MFN 12-086, Revision 2

GEH Final Response to RAI 3.9-277

NRC RAI 3.9-277

The staff's question is in regard to the use of specific types of welds in the ESBWR steam dryer and the justification for fatigue and quality factors for each weld type.

Figure 1 - Typical Weld Joints

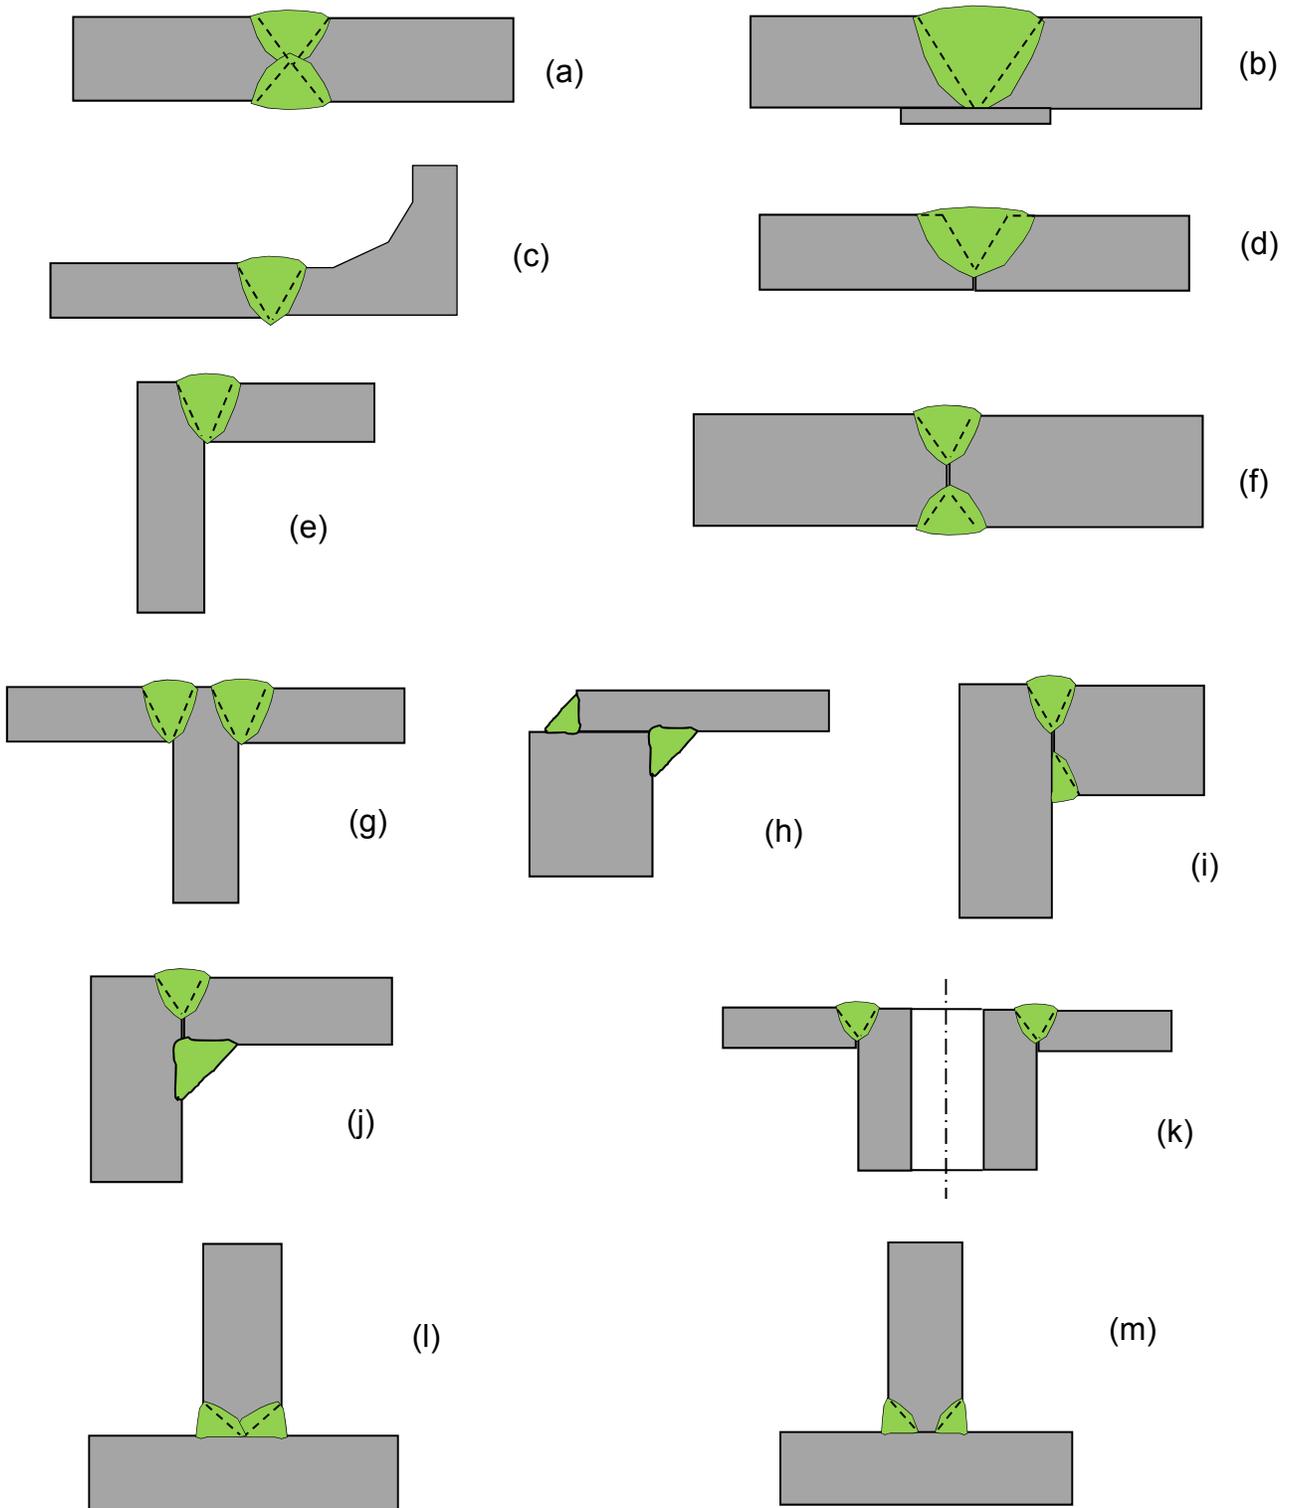
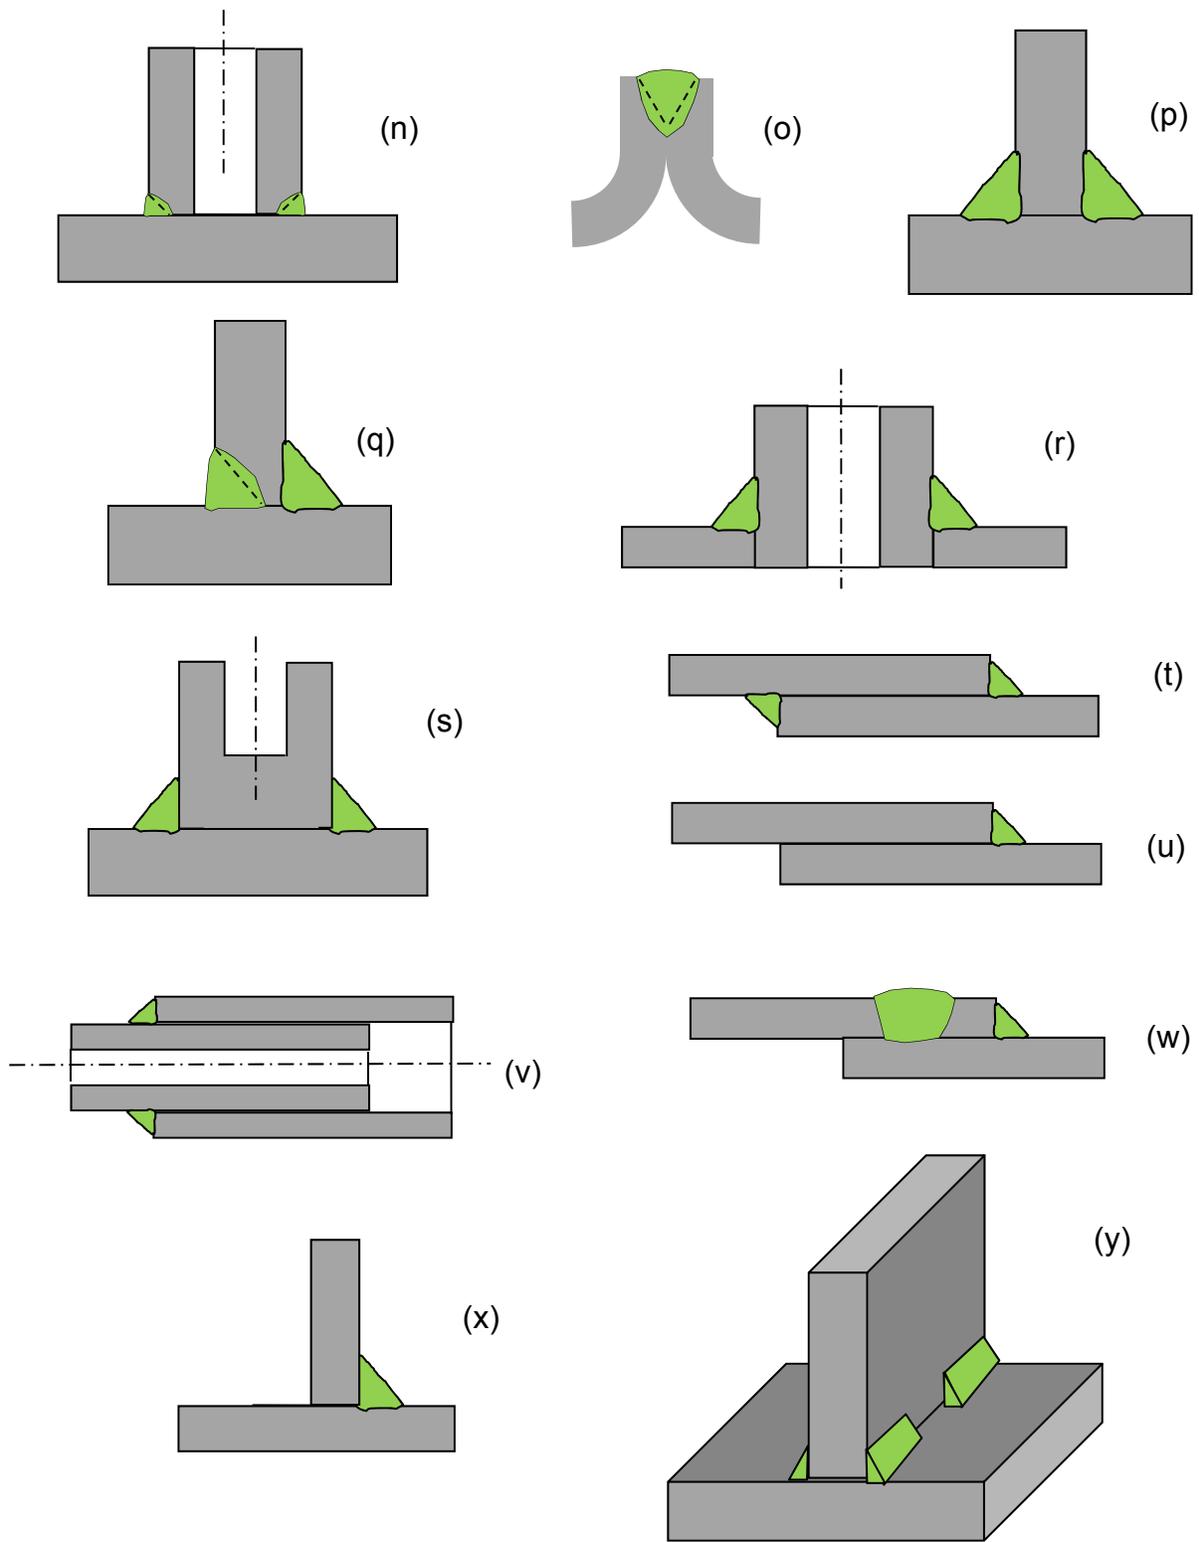
GEH is requested to discuss the use of specific types of welds in the ESBWR steam dryer and the justification for fatigue and quality factors for each weld type. In addition, GEH is requested to discuss the [[]] in the ESBWR steam dryer as described in NEDE 33313P, Rev 2. During the audit, the staff asked GEH to address the [[]] in the ESBWR steam dryer design, and how the [[]] will be conducted. At the audit, GEH made a definitive statement that the ESBWR steam dryer design [[]]. The staff noted that this is inconsistent with NEDE 33313P, Rev 2. Please provide clarification if [[]] in the ESBWR steam dryer.

- a.) Butt joints, NG-3352 Type I. Butt joints are full penetration groove welds, Figures 1(a) and 1(c). [[]].
- b.) Corner joints, NG-3352 Type III and some Type V. Corner joints are constructed using groove welds or fillet welds. As indicated in DCD 26A6642AN section 3L.2.3 (ref. 7), joints are designed [[]].

c.) T-joint, NG-3352 Type III, some Type V and some Type VII. T-joints are constructed using groove welds or fillet welds.

- Type III T-joints will use full penetration groove welds, Figure 1(l), [[

e.) Edge joint, NG-3352 Type VI. This joint design, Figure 1(o) is not used since the edge joint [[

f.) Plug or slot welds and intermittent welds, NG Type VIII will not be used in ESBWR steam dryer design. Figure 1(w) shows a lap joint with a fillet weld and plug weld similar to that used in some thin wall vessels. Plug and slot welds [[

- $f = 1$, full penetration groove welds, welded from both sides, e.g. figures 1(a) and 1(l).
- $f = 1$, full penetration groove welds, welded from one side, provided the component design has allowed the backside to be accessible for inspection, figure 1(c).
- $f = 2$, full penetration from 1 side where backing is used, figure 1(b).
- $f = 2$, full penetration groove welds such as figures 1(e) and 1(g), if the component design has not allowed weld backside inspection capability.
- $f = 4$, partial penetration welds
- $f = 4$, fillet welds

Figure 6.5: Groove weld geometry and nomenclature (ref. 1).

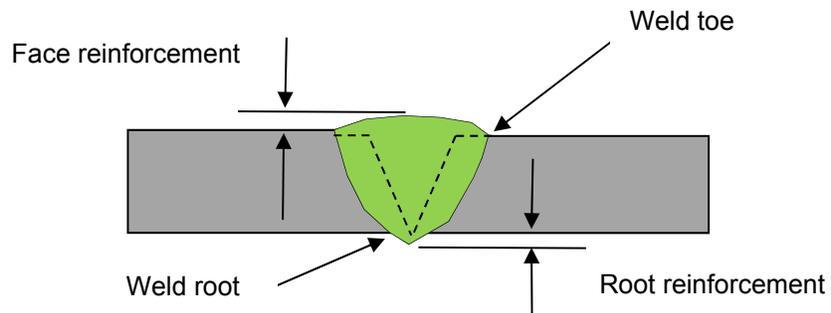
3.) *The draft RAI response states in section 3.1.1 "Full penetration groove welded butt joints, corner joints and T-joints: NG-3352 Types I and III:*

If GEH is consistently following NG 4424 and NG 4426, it appears to be unnecessary to apply a 1.4 weld fatigue factor to "secondary" full penetration welds, in recognition of "the local discontinuity present at the toe of the groove weld due to weld reinforcement." As noted in the response, NG specifies 1.0. Please provide an explanation for this apparent inconsistency. Also, confirm or correct staff's understanding that GEH has committed to NG including NG 4424 and NG 4426, with the only exception being the weld fatigue factors and the weld quality factor applied to "non-structural" welds.

In DCD 26A6642AK (ref. 15) section 3.9.5, GEH committed to the design of reactor internals structures classified as non-safety related as complying with the requirements for ASME BPV Code Article NG-3000 except for the weld quality and fatigue factors for secondary structural welds. Therefore, [[

The [[

groove weld.]] of the
